ANP-10297Q1NP Revision 1

Topical Report

Responses to Requests for Additional Information for the Review of THE ARCADIA® Reactor Analysis System for PWRs Methodology Description and Benchmarking Results Topical Report

The ARCADIA® Topical Report [1-1] was submitted to the US Nuclear Regulatory Commission for review in March 2010. A draft set of Requests for Additional Information (RAI) was released by the NRC in December 2010. This document addresses the AREVA NP Inc. responses to these RAIs.

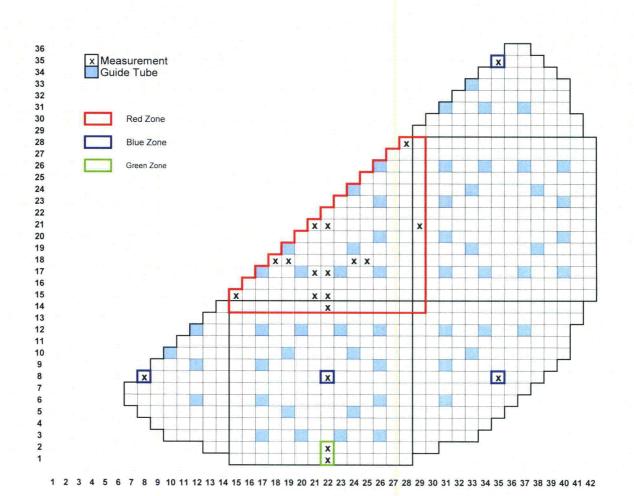
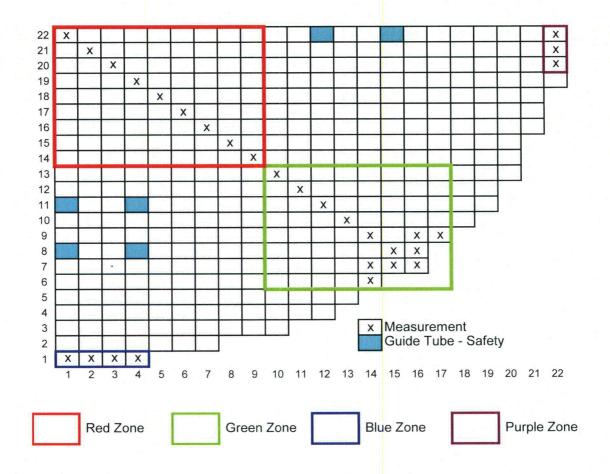
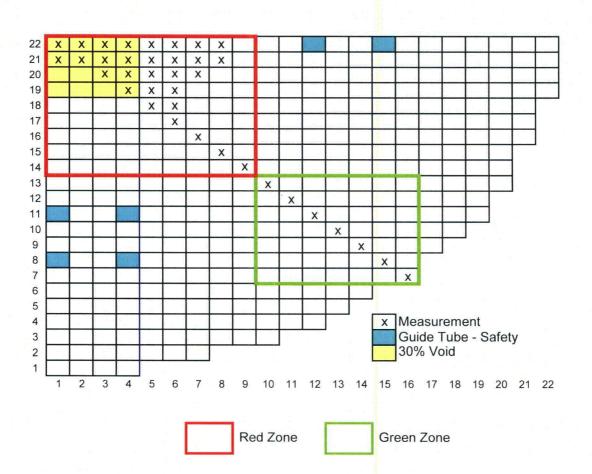
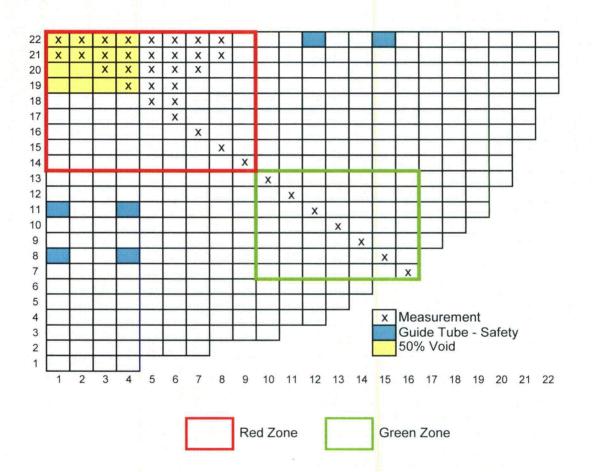
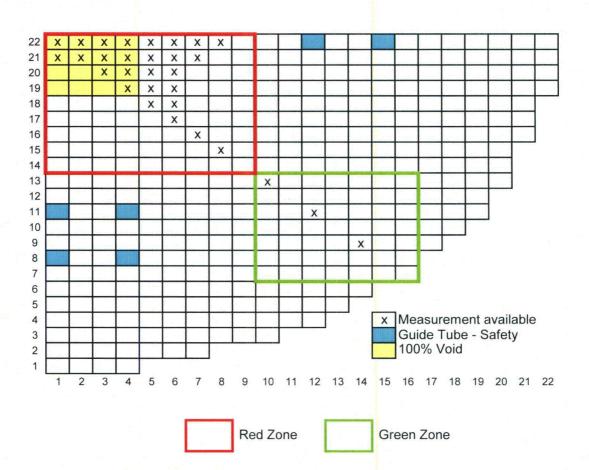
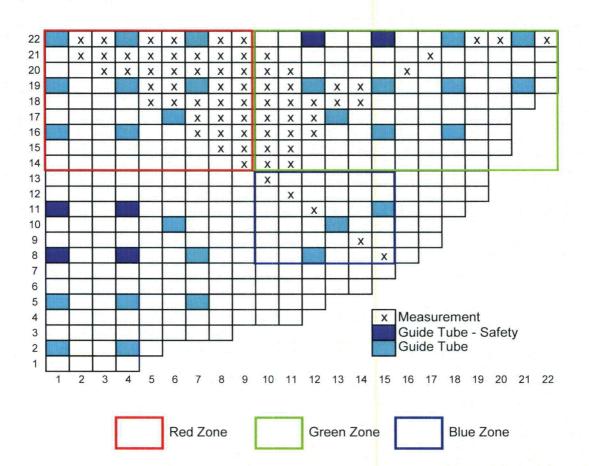
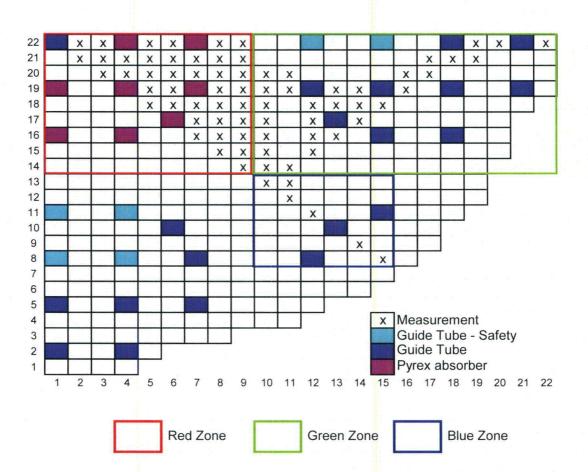
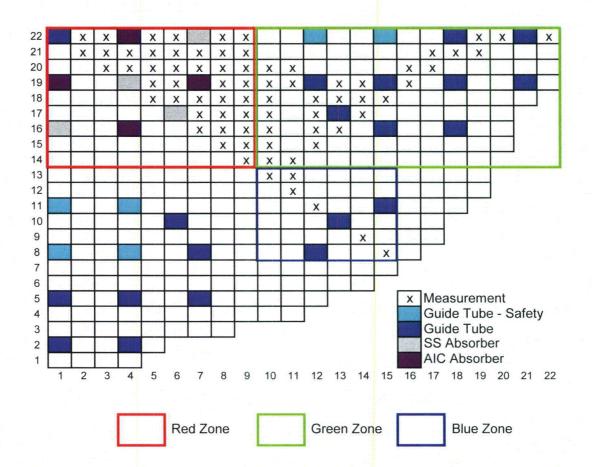
RAI 15 Please provide fission rate distribution maps similar to Figure 12.2.1-1 for other criticals as well. Also please the predicted and measured peak pin fission rate locations, the peak pin fission rate differences and maximum, minimum fission rate differences in the fission rate distribution comparison in Tables 6.2-6 through 6.2-10 [Page 6-7].

Fission rate distribution maps similar to Figure 12.2.1-1 are presented for each critical configuration in Figure 15-1 through Figure 15-16. Due to their size, maps for the EPICURE and KRITZ configurations are split into smaller maps. In these cases a description of the complete map is presented first with the definition of the zones that are used for the smaller maps. The Babcock & Wilcox experiment fission rate distributions are updated as part of the response to RAI-36.

Note: In revisiting the calculations of the critical experiments presented in the Topical Report, while responding to the RAIs, some minor errors were found in the modeling and post-processing of the fission rate distributions in the EPICURE UH1.4, KRITZ-KWU, and B&W 1980's experimental programs. Therefore, some of the RMS values presented in this response are slightly different from those presented in Section 6.2.2 of the Topical Report. All of the changes have improved the results as compared to those in the Topical Report except for Configuration 20 of the B&W criticals and the KRITZ-KWU criticals where the RMS increases slightly.

Figure 28-G1-1: Plant G1 Cycle 26 Critical Boron Concentration vs. Burnup

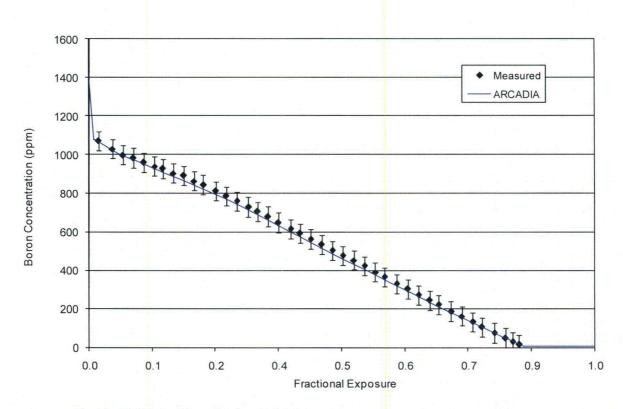
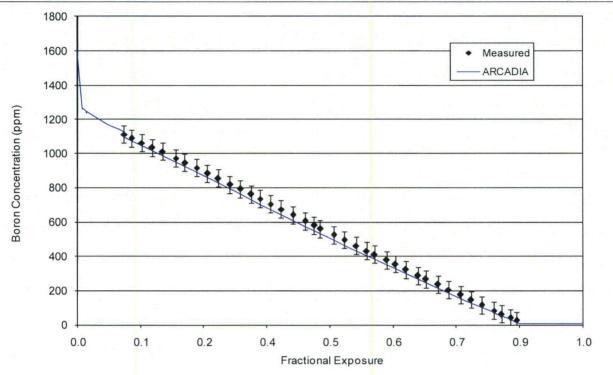
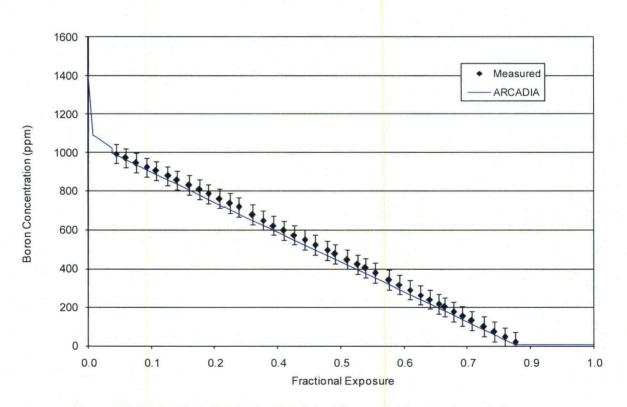
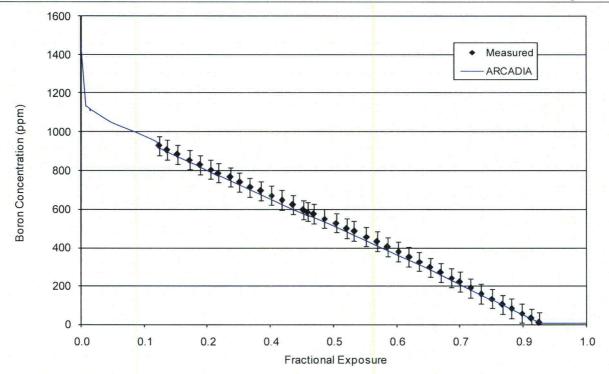
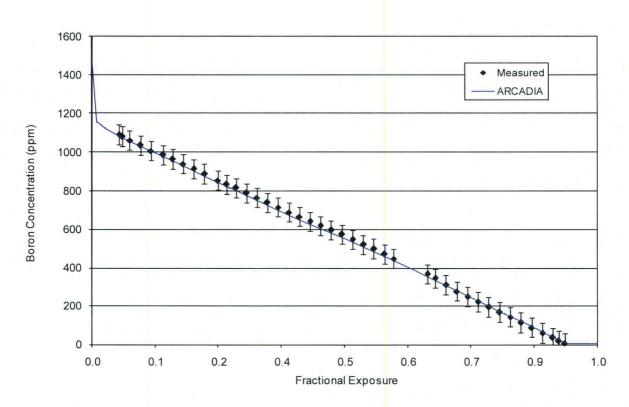
RAI 28 Plant G1 Cycle's 27 and 28 had a BOC B10 abundance of 19.2%. Also, Cycle's 29 and 30 used enriched B10 at about 30%. The report states that the Cycle 26 HZP boron measurement "may be suspect because of the B10 isotopic abundance was not measured". However, there are no unexpected comparisons at BOC HFP, which indicates that no additional B10 correction should be necessary at HZP. The report does not clearly describe which boron measurements are adjusted for B-10 content, and which are not. B10 corrections, both at HZP and HFP (i.e. B-10 depletion, if included) should be applied consistently for all cycles and should be clearly documented. [Page 10-31,1035]

Erroneously the critical boron adjustment in Table G1 10.3.4-1 and in Figure G1 10.4.4-1 of the Topical Report for Cycle 26 was applied to the calculated values to make them relative to the measured B-10 abundance instead of using the assumed measured B-10 abundance to adjust the measured critical boron concentrations such that they are relative to concentrations with natural boron. The values have been updated and are presented In Table 28-G1-1 and Figure 28-G1-1 (see below).

Figure 31-A-1: Boron Differences

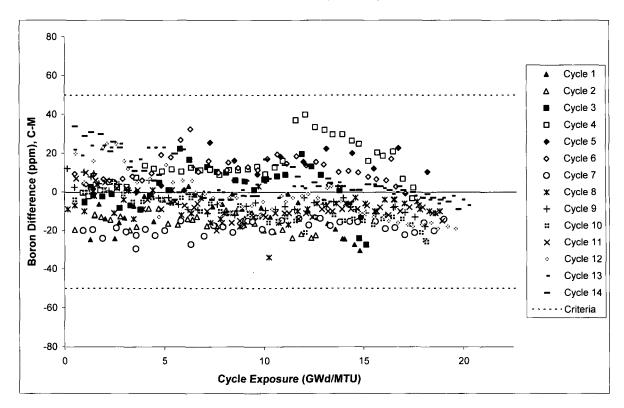
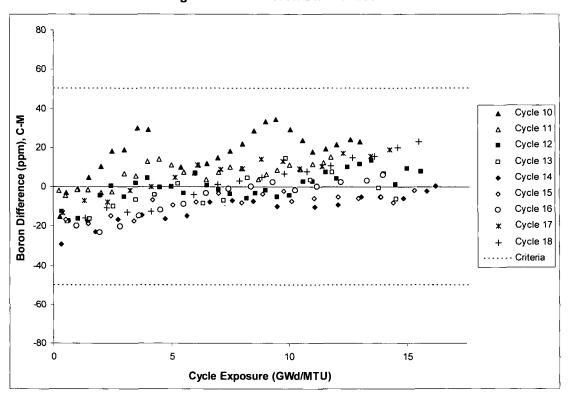
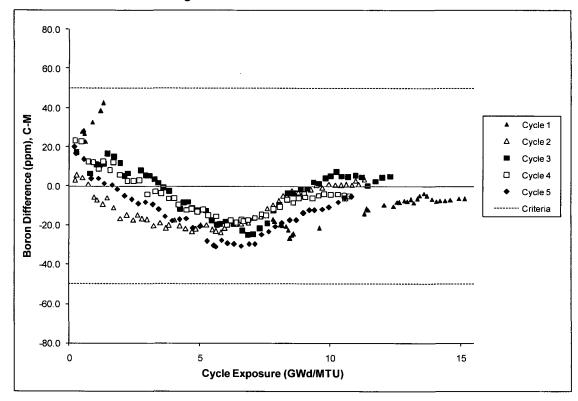
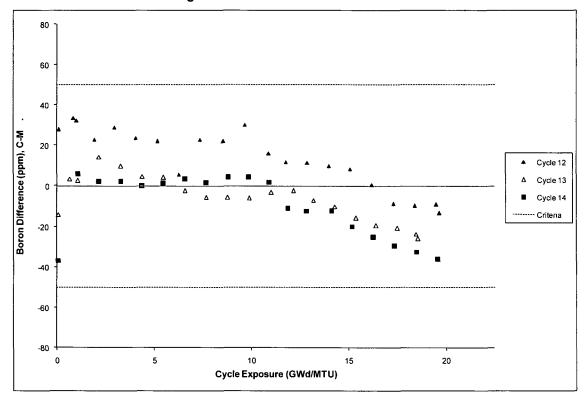
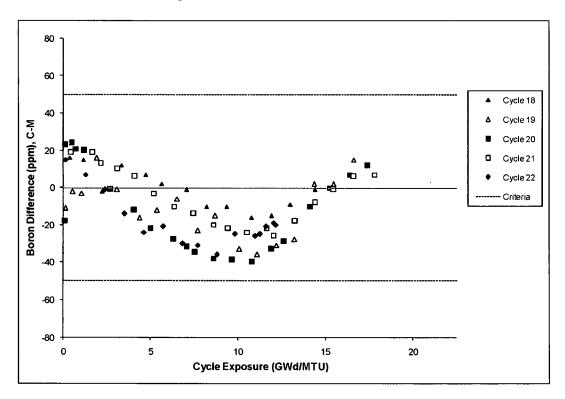
RAI 31 The boron letdown curves are presented for each cycle individually as a function of fractional cycle length. This scale is confusing because it prevents some comparisons from cycle to cycle, and inhibits the ability to approximate cycle length-based effects, such as gadolinia depletion, B- 10 depletion, and design implications for 24 vs 12 month cycles, etc. Furthermore, the letdown curves are presented on an absolute value scale, which makes individual deviations very hard to discern. A summary plot of boron difference for all cycles (to compare against each other, potential by plant), plotted verses a non-relative scale such as cycle exposure would be useful. [Page A-9+]

Summary plots of the boron deviations are provided. These plots use an absolute scale for burnup and present the boron deltas for all cycles by plant.
